**Addendum #2**

**Bid Opportunity: RFT-2025-166 - Operations Centre Garage Expansion**

ADD  
#E01

ADD  
#M01

FOUNDATION SECTIONS

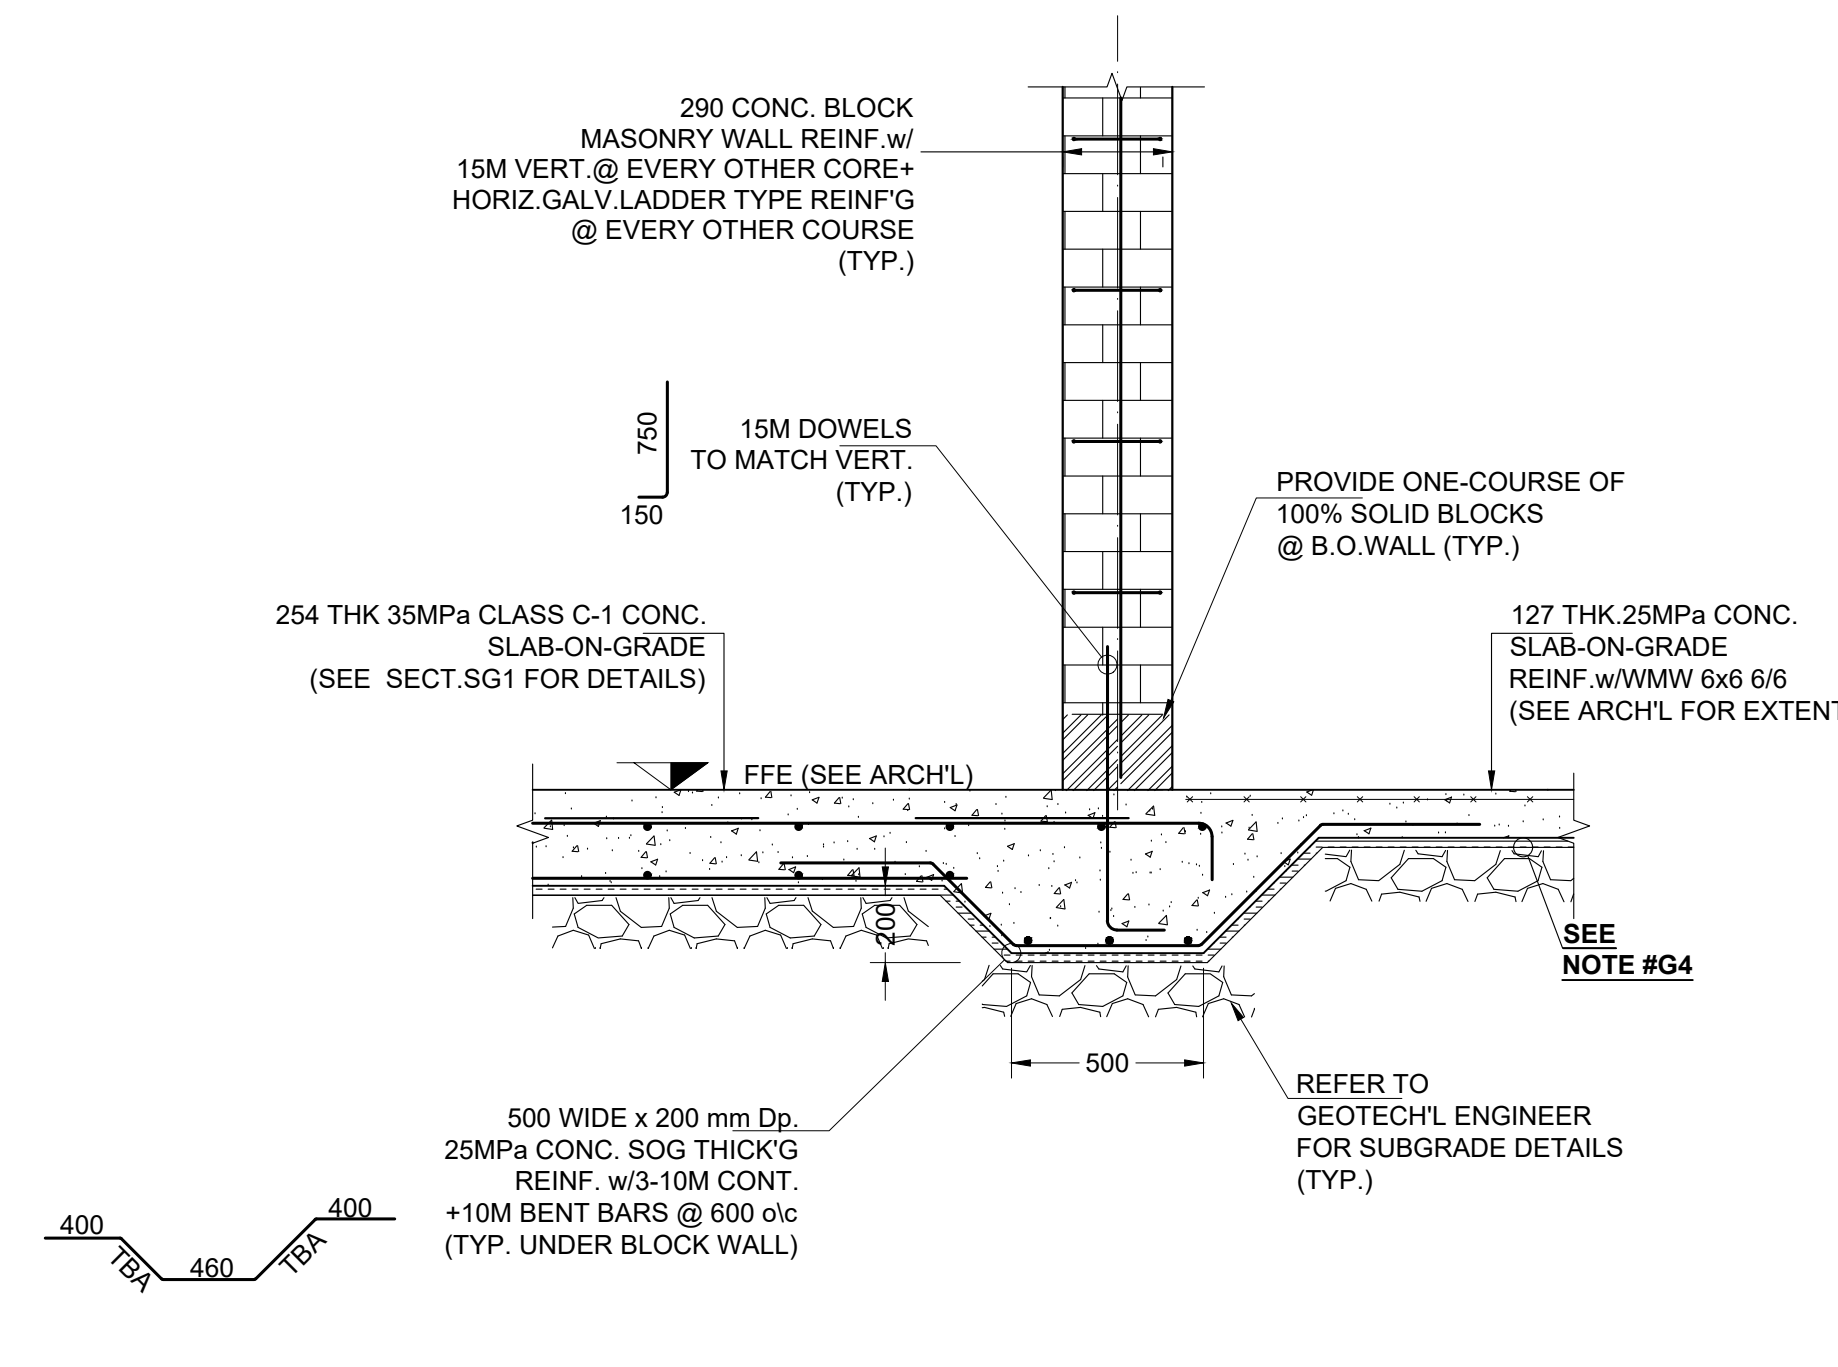
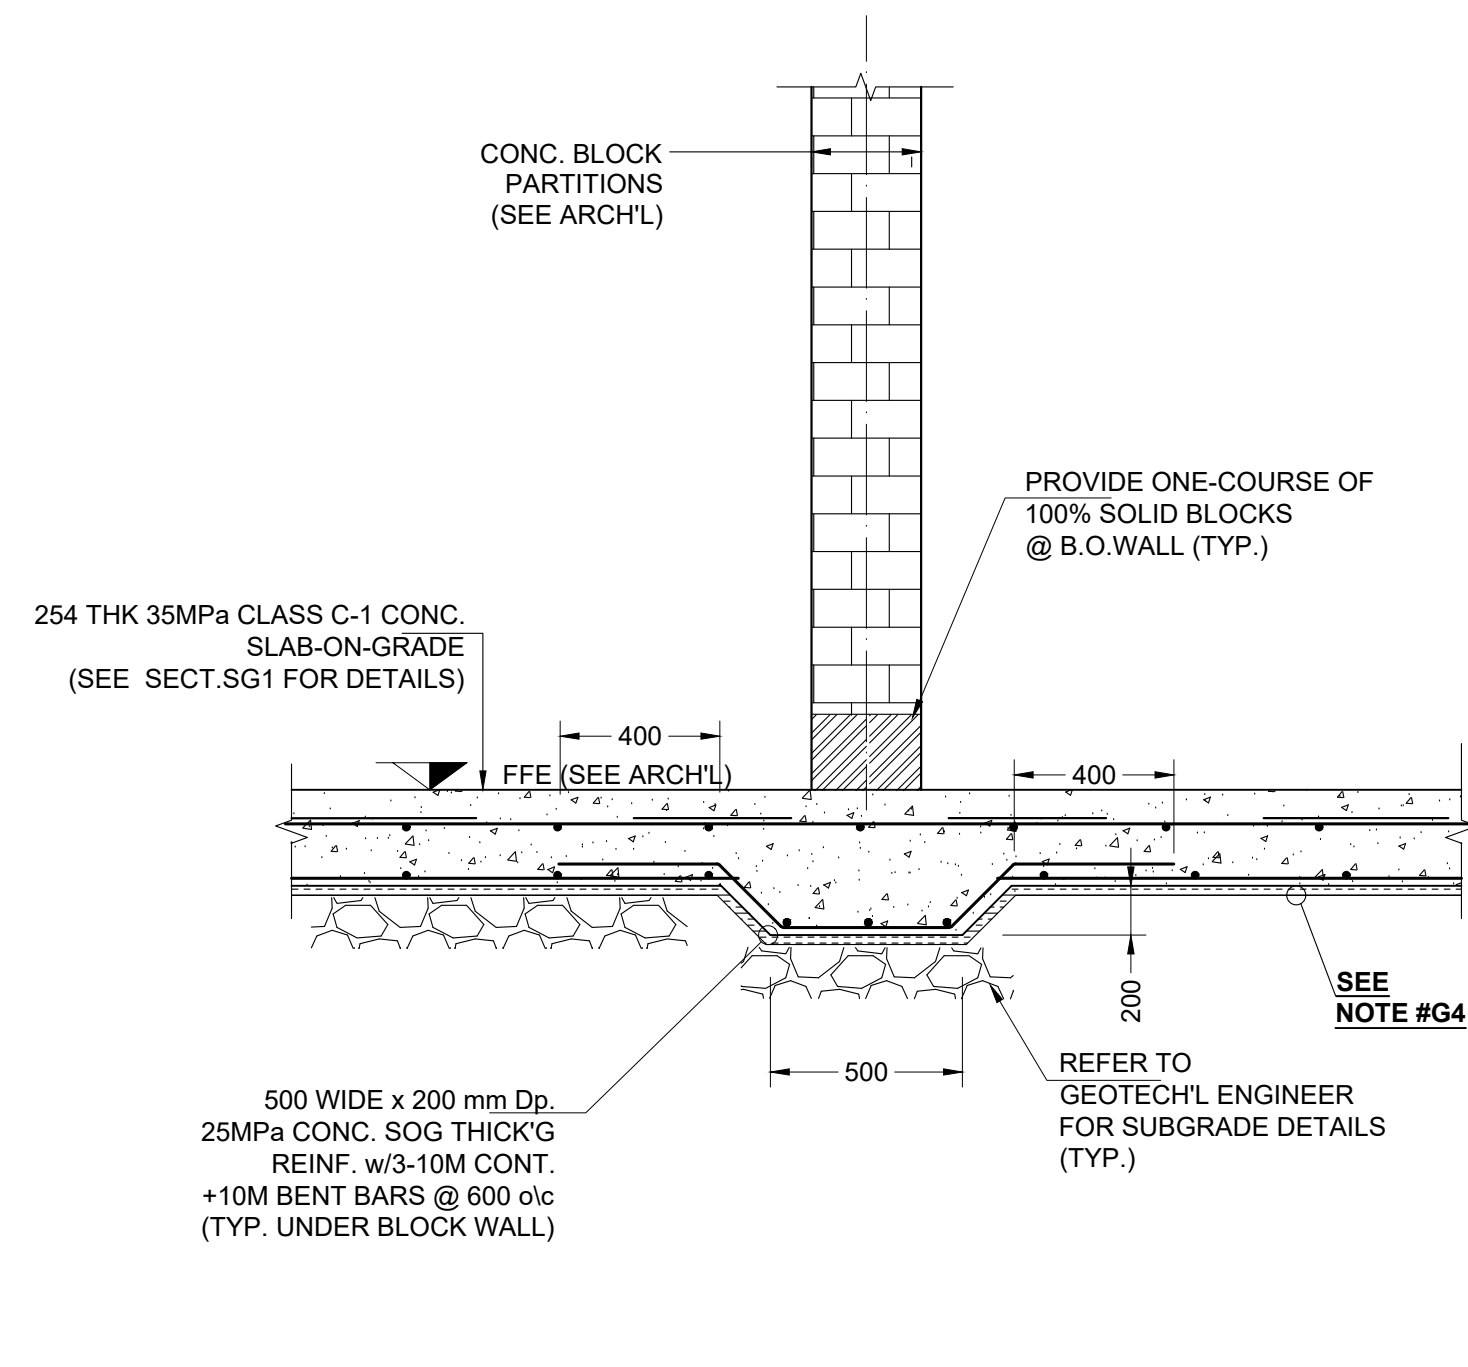
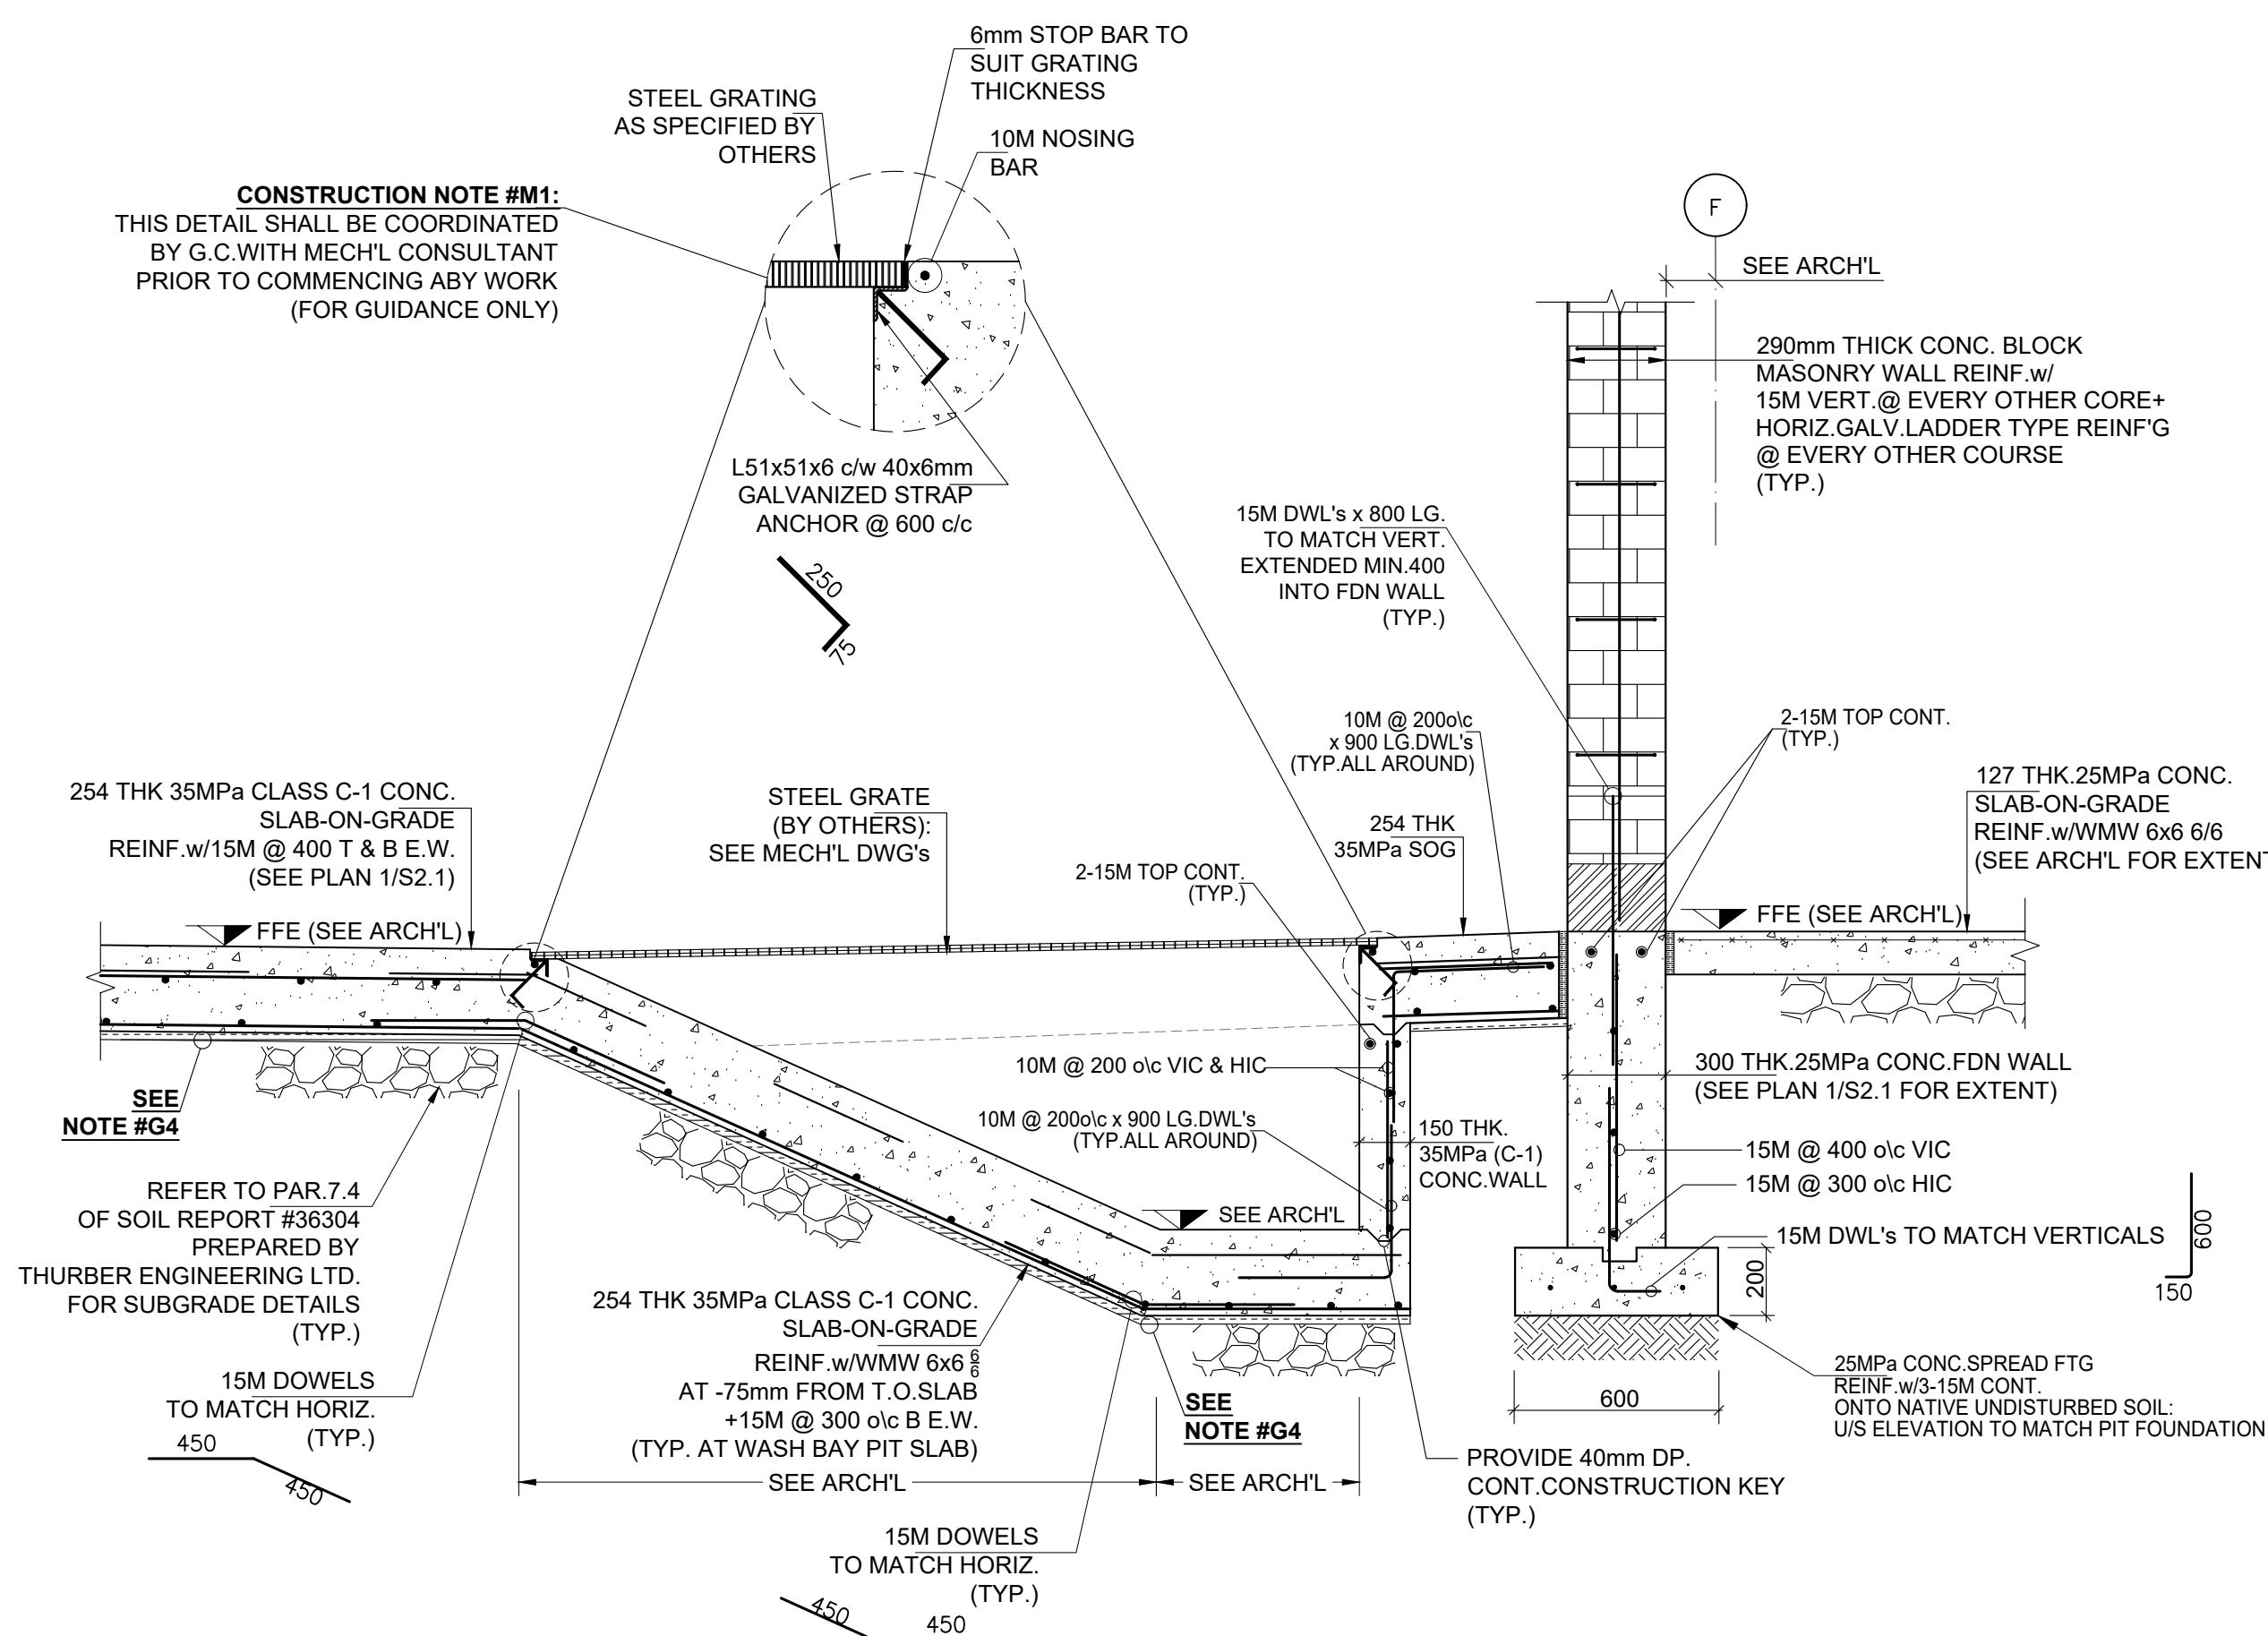
Conflicting notes between plan A-102 notes 3in. tk. insul. at perimeter and then plan S2.1 note G4 states 2in. tk?

**Answer 12:** For clarification, as per the architectural drawing A-102 the thickness of the perimeter insulation will be 3 in. See attached & updated structural drawings S2.1 & S2.2 indicating the thickness of the perimeter insulation has been revised from 2 in. to 3 in.

<b>CONSTRUCTION NOTE #G4</b> (REQUIREMENT FOR INSULATION LAYER): PROVIDE 3" THICK X 4'-0" WIDE 'FOAMULAR 400 HIGH DENSITY INSULATION' AROUND PERIMETER OF SLAB AND 1" THICK 'FOAMULAR 400 HIGH DENSITY INSULATION' FOR REMAINDER OF INTERIOR AREAS.	<b>CONSTRUCTION NOTE #1</b> THESE DRAWINGS SHOW THE COMPLETE STRUCTURE. IT IS THE GENERAL CONTRACTOR'S RESPONSIBILITY TO CHOOSE CONSTRUCTION METHODS AND CARRY OUT THE WORK BASED ON SITE CONDITIONS.

M1  
S5.1  
SECTION  
SCALE: 1:20

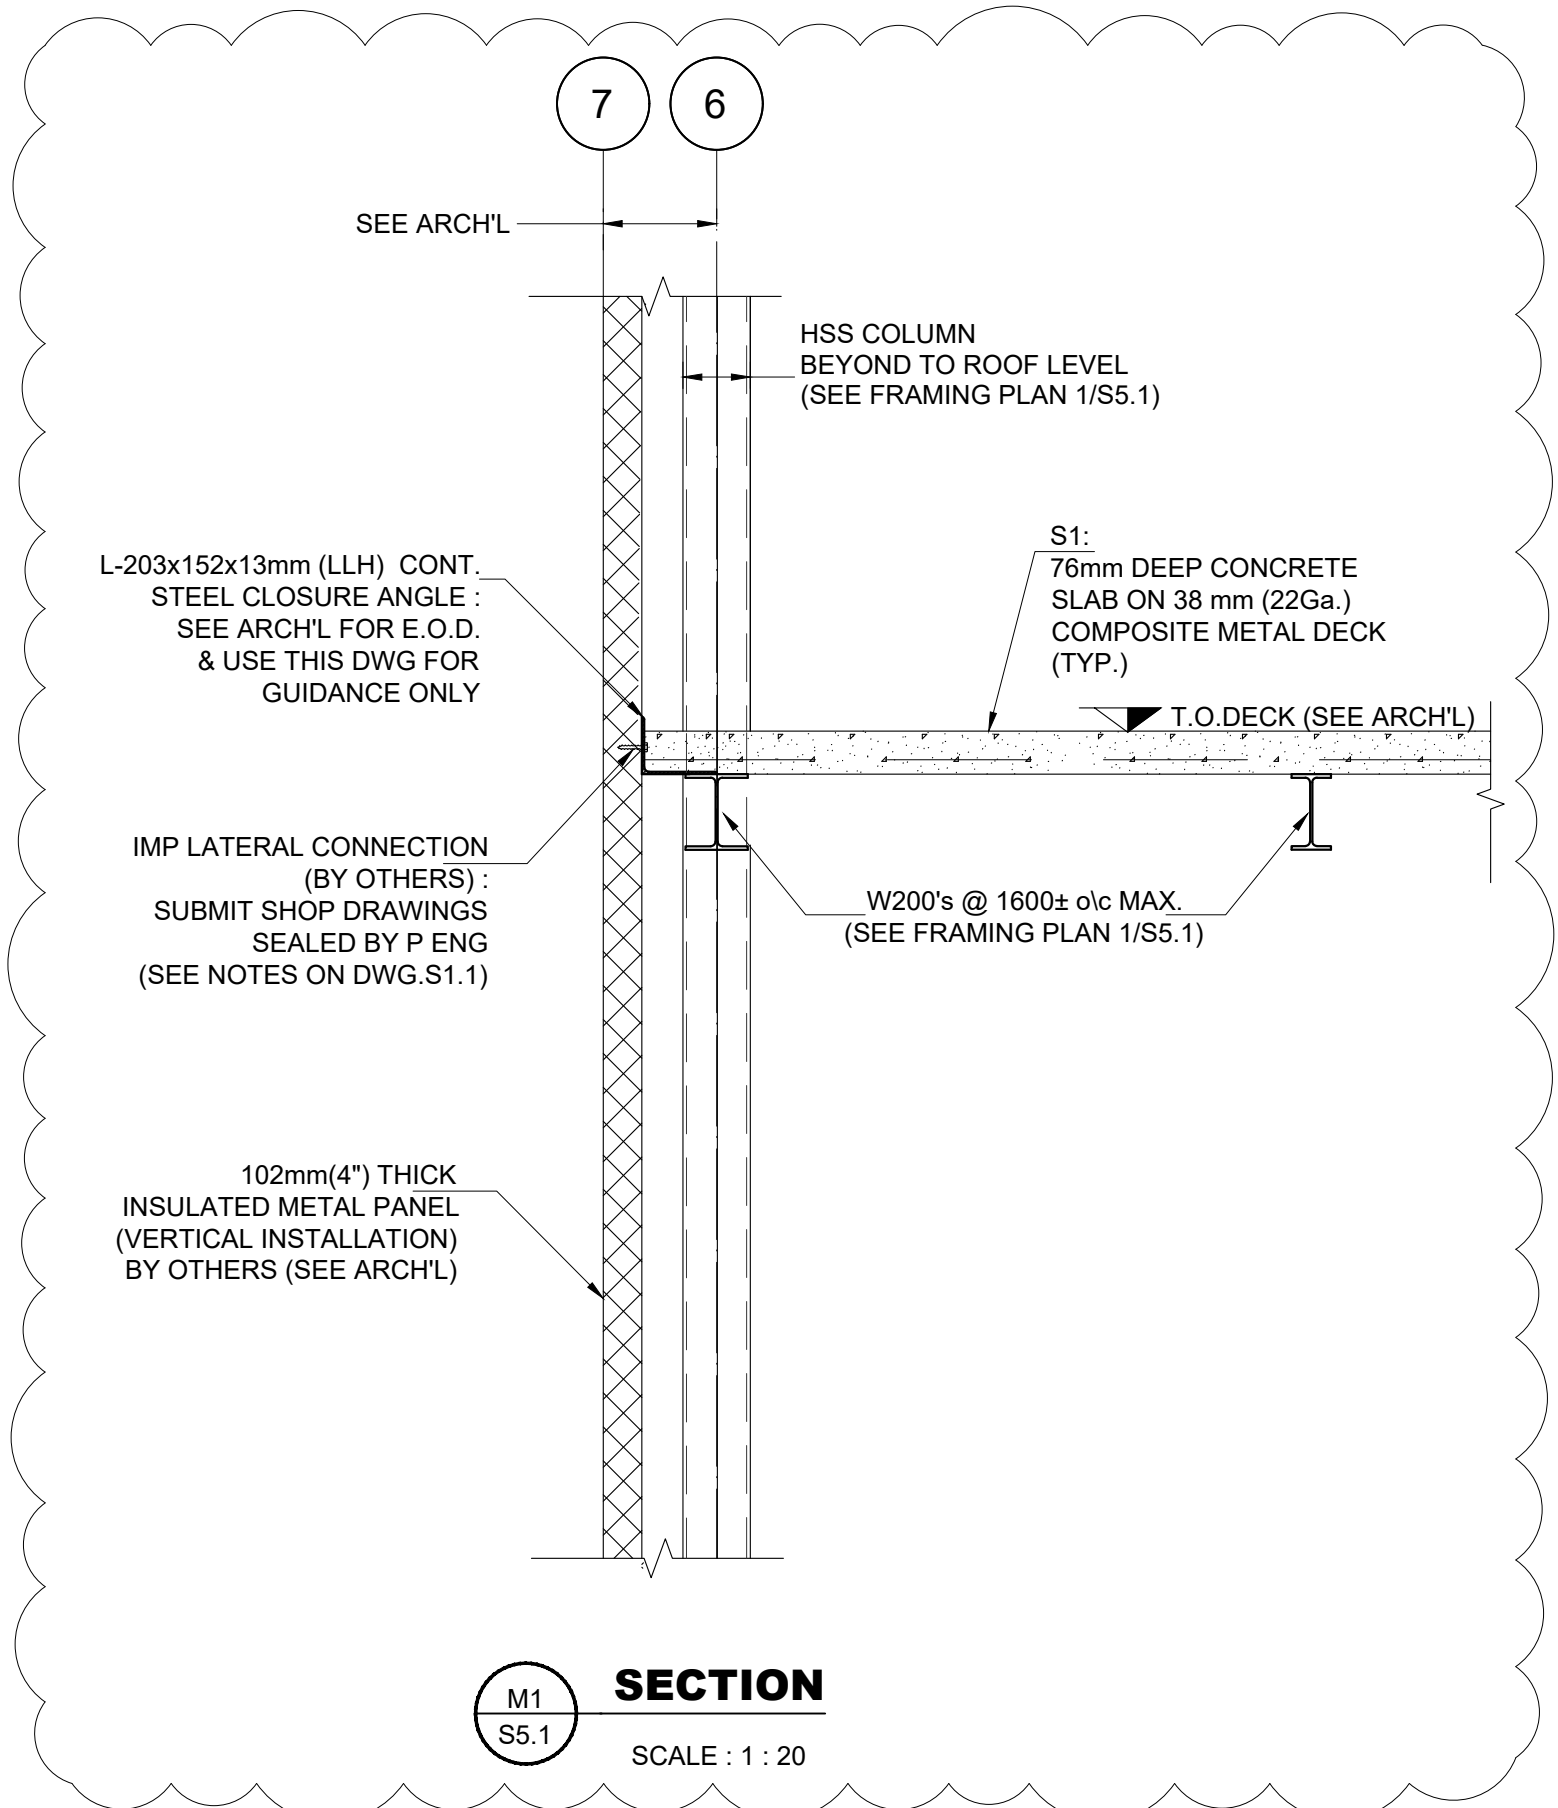
Plan S5.1 section M1/S5.1 shows W200 beam wrong orientation.

**Answer 13:** See attached & updated structural drawing S5.1 with the correct orientation for the W200 beam.
